TENDER 2018-06 ADDENDUM #1

To: All Bidders
Project: Embro Fire Station Addition
Date: June 26, 2018

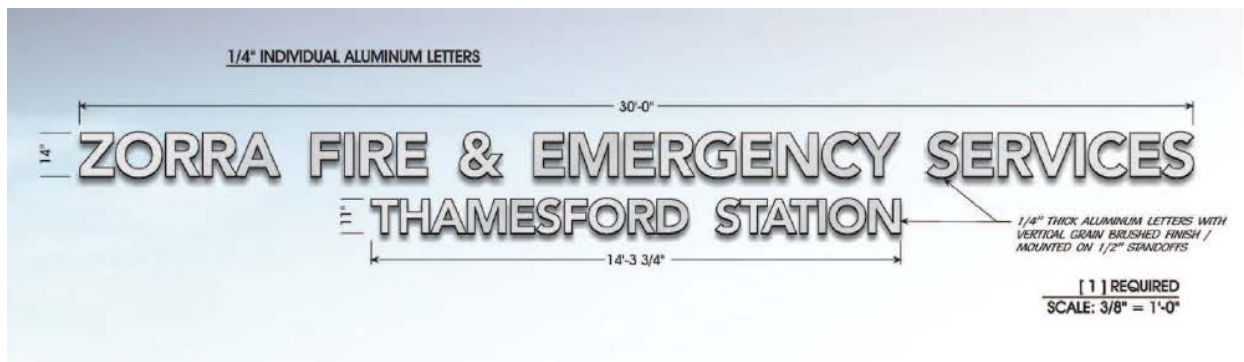
1. Q – Which Bay is to be bricked in?
A – C.2.1 (4th bullet) should read “Existing Bay 3”.
2. Q - Is existing lighting to be replaced?
A – All existing lighting to be replaced/ upgraded to LED lighting.
3. Q – Please confirm overhead door size.
A – C.2.1 (3rd bullet) – Door size to be 14’ x 12’ to match the existing door size.
4. Q - Please confirm bay 2 is to remain clear of ancillary rooms.
A – Yes, Bay 2 should remain clear of ancillary rooms.
5. Q – Clarify Station Signage.
A – Station signage to read:

ZORRA FIRE & EMERGENCY SERVICES EMBRO STATION

As per sample below:
